**FINAL FINDINGS AND DETERMINATIONS**  
**Type II Zoning Permit**  
**Foothills Solar Park and Substation**  
**Special Review #915**

**Posted: January 18, 2016**

**TITLE:** Foothills Solar Park and Substation, Special Review #915

### **Water/Wastewater:**

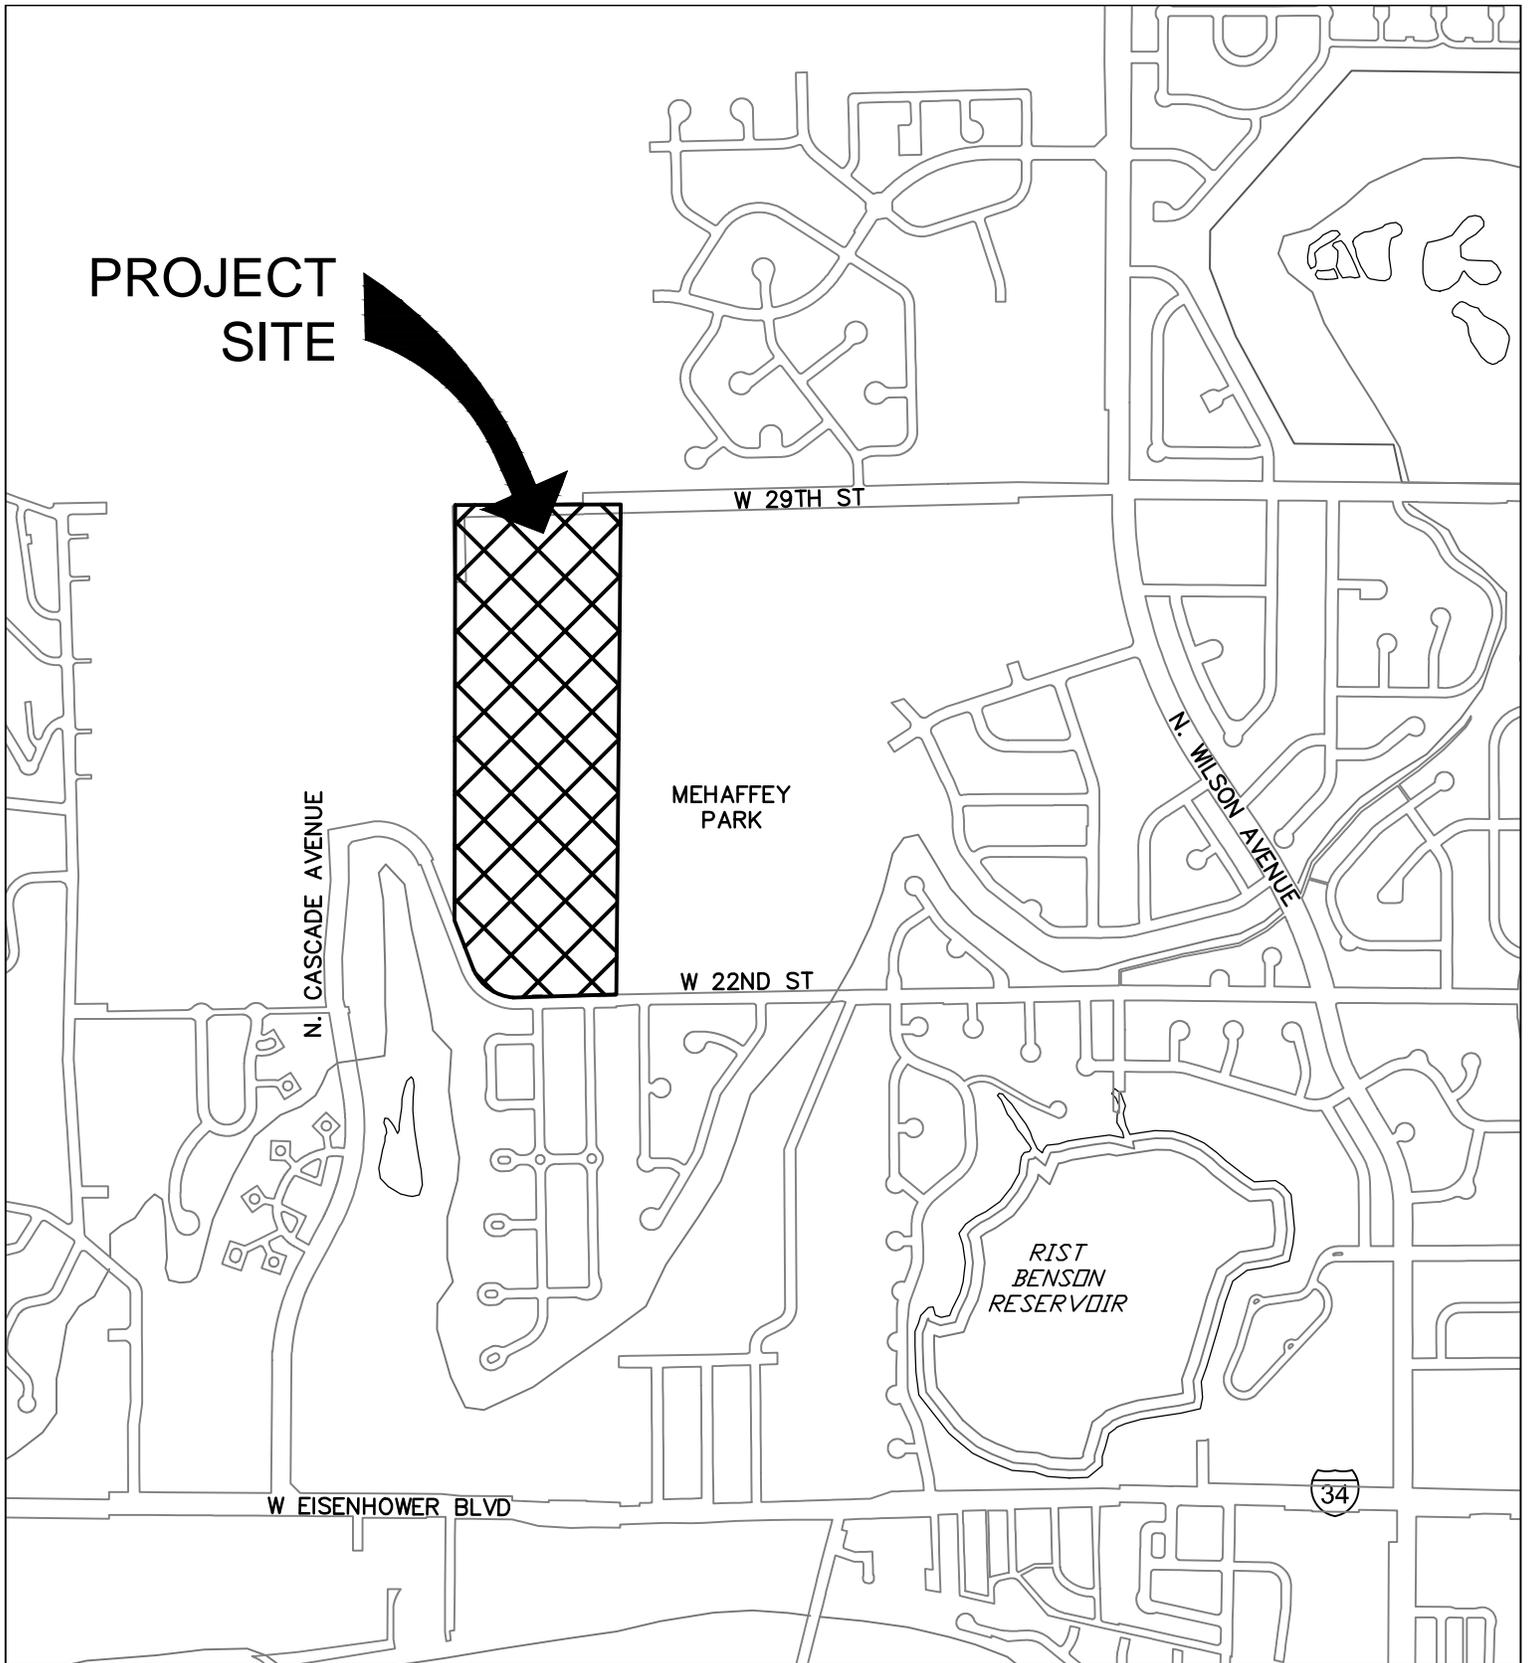
1. Sheet C200-The crossing is missing the insulation design as previously requested.
2. Landscape plan -- do not add trees (PI HE) directly east of the east side of the pump station building.
3. Landscape plan -- please add the Total Irrigated Area amount on the Landscape plan.
